SUNDRY NOTICES AND REPORTS ON WELLS (DO NOT USE THIS FORM FOR PROPOSALS TO DRILL OR TO DEEPEN OR PLUG BACK TO A DIFFERENT RESERVOIR. USE "APPLICATION FOR PERMIT" (FORM C-101) FOR SUCH PROPOSALS.)		WELL API NO. 30-005-60964

2. Name of Operator Vanguard Operating LLC		6. State Oil & Gas Lease No.
3. Address of Operator 5847 San Felipe St., Ste. 3000, Houston, TX 77057		7. Lease Name or Unit Agreement Name Redman "OY" State

LEASE/WELL: REDMAN "OY" STATE #1Y
 LOCATION 660' FSL & 760' FEL
 P-35-T04S-R24E
 CO/ST: CHAVES COUNTY, NEW MEXICO
 FIELD: PECOS SLOPE; ABO
 API NO. 30-005-60964

BEFORE P&A

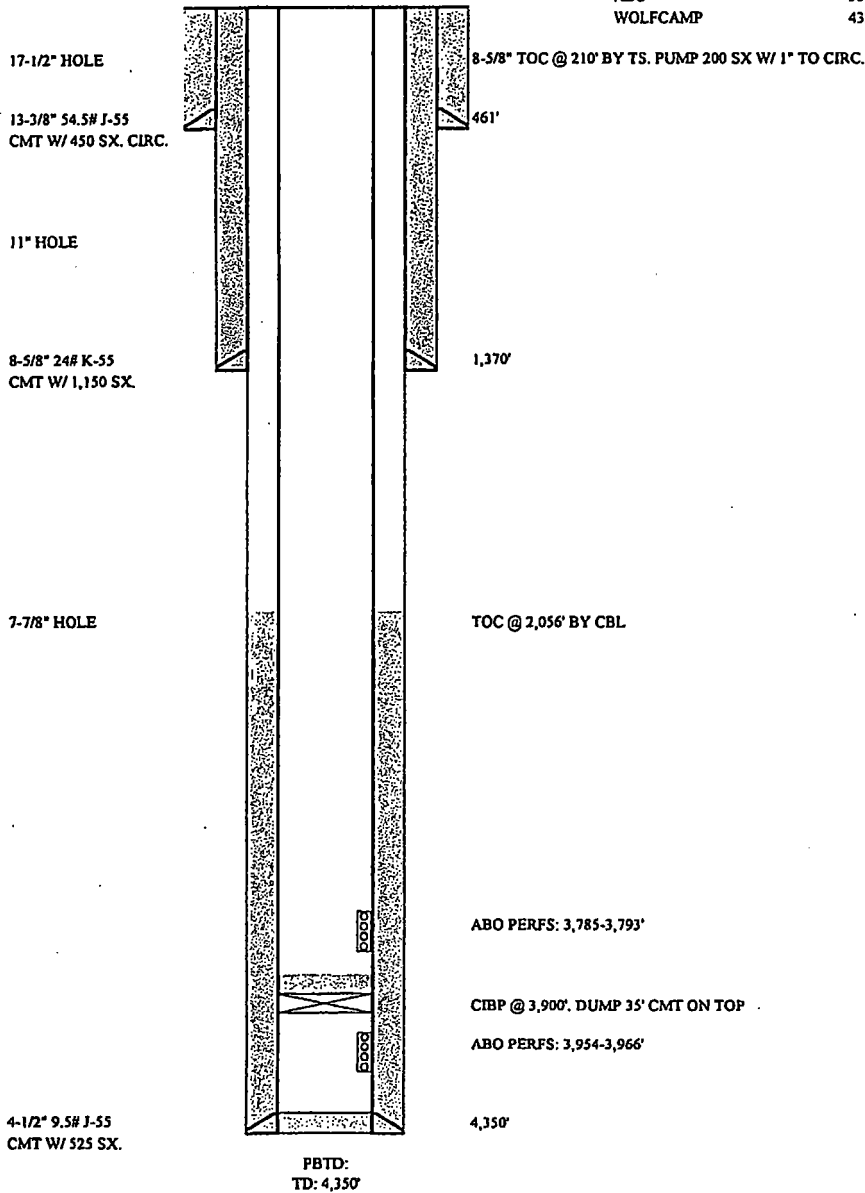
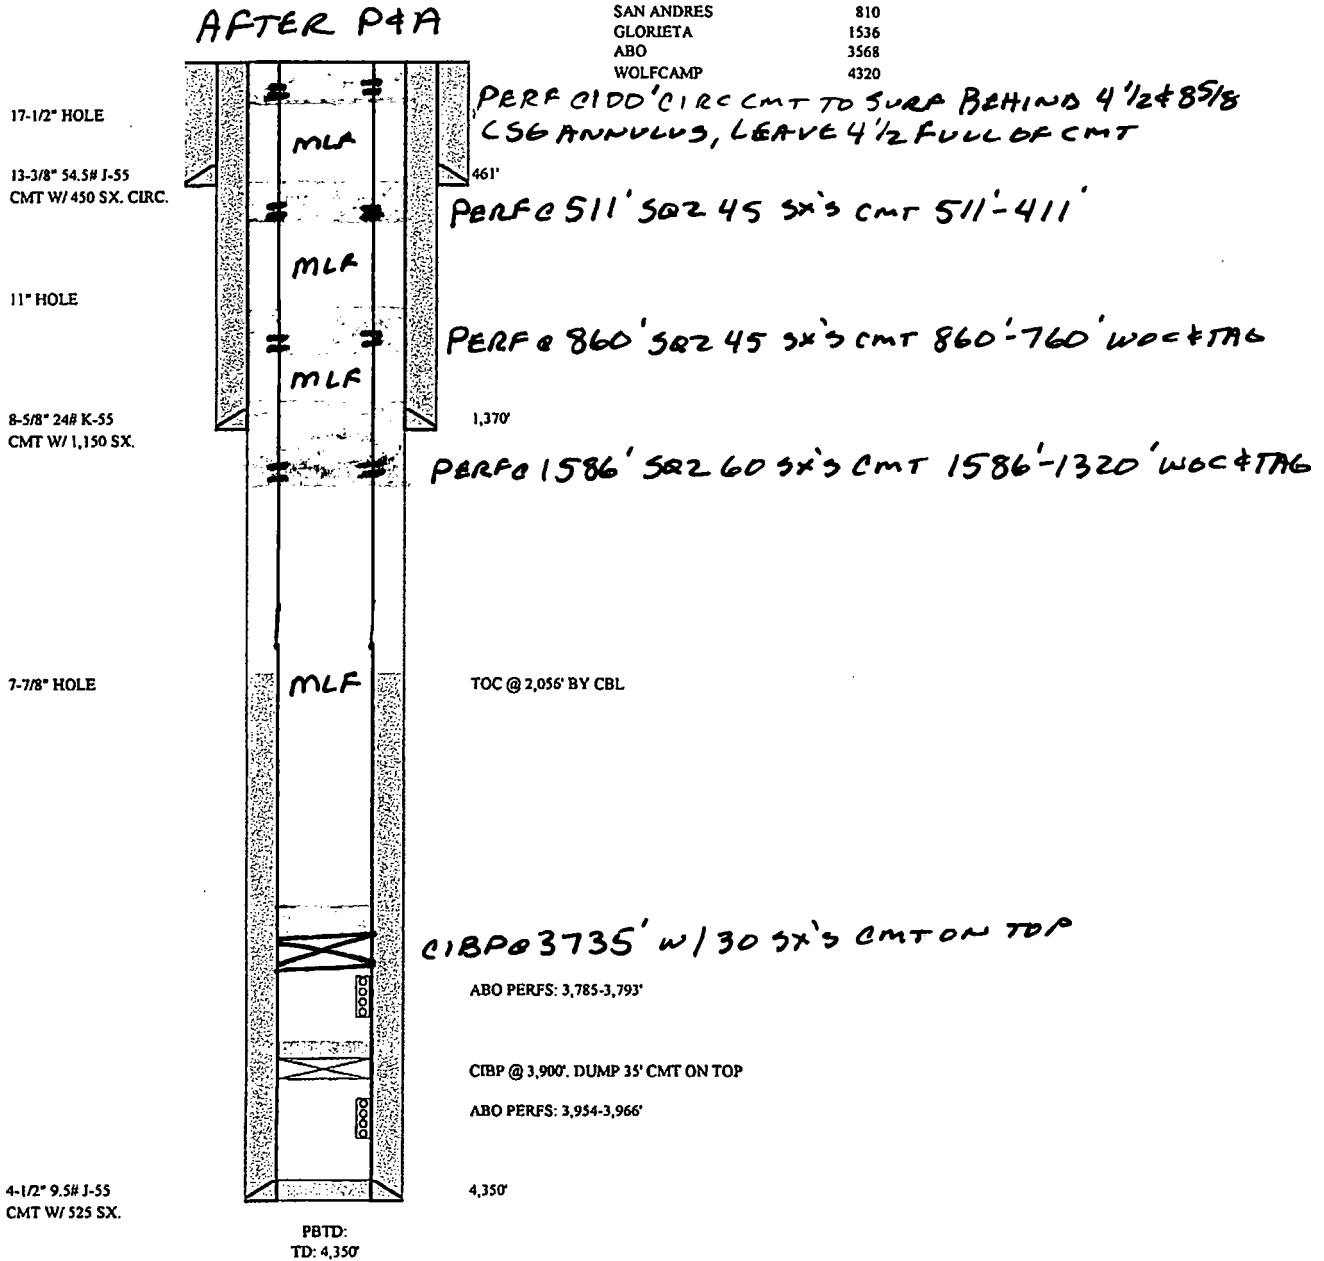
1. Notify OCD 24 hrs prior to MIRU to P&A.
2. Set CIBP @ 3735' RIH w/tbg & tag circ hole w/mud laden fluid test csg.
3. Spot 30 sx's "c" cmt 3735'-3500' WOC & tag if csg don't test (CIBP and ABO perfs).
4. Perf @ 1586' sqz 60 sx's "c" cmt F/1586'-1320' (Glorieta, 8 5/8" Shoe) WOC & tag. *WOC + Tag - Perf @ 1420'*
5. Perf @ 860' 45 sx's "c" cmt 860'-760' (San Andres) WOC & tag perf @ 511' sqz 45 sx's "c" cmt 511'-411' (13 3/8" Shoe) perf @ 100' circ cmt to surf behind 4 1/2" x 8 5/8" csg annulus leaving 4 1/2" inside full of cmt to surf.
6. RD P&A equip, cut off off wellhead, install dry hole marker, clean location, move off.

** See Attached COA's* *Must be plugged by 10-15-19*
I hereby certify that the information above is true and complete to the best of my knowledge and belief.
